SECTION DRIVE MODULE (SDM) MASTER SENSE UPDATE

In August 2025, the Matrix® 908 received a new software update (v1.52), featuring Last Pass Guidance Mode as the key enhancement.

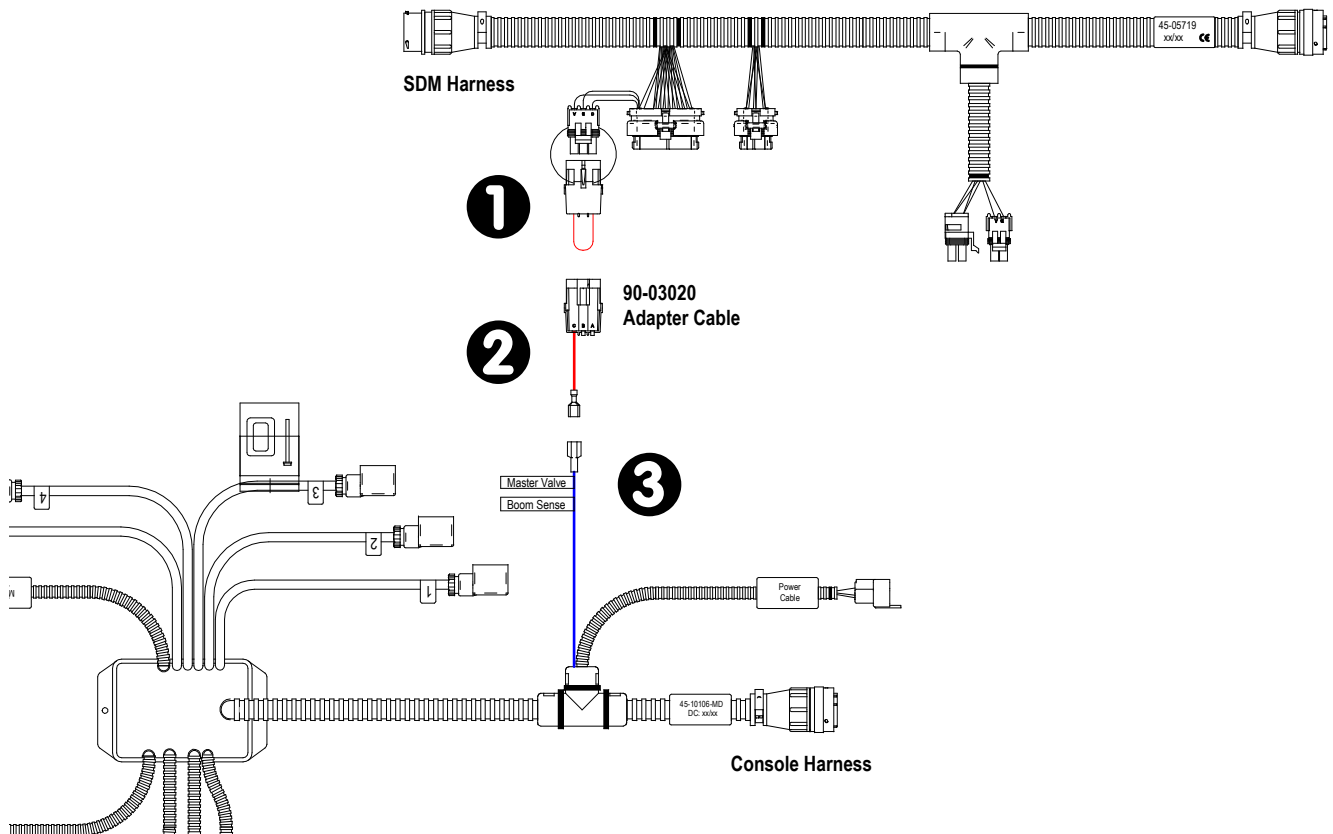
As part of this update, the Matrix 908 requires the controller master switch to be in the **OFF** position when a job is opened before mapping is allowed. SDM harnesses with the master sense *jumped* (as shown in ❶ below) do not meet this requirement. The adapter cable in kit 90-03020 resolves this issue.

1. Remove and discard jumper ❶.
2. Connect adapter cable 90-03020 ❷ to the mating connector that the jumper ❶ was removed from.
3. Connect the spade terminal at the other end of the adapter cable to the master boom sense ❸ on the controller main/console harness.
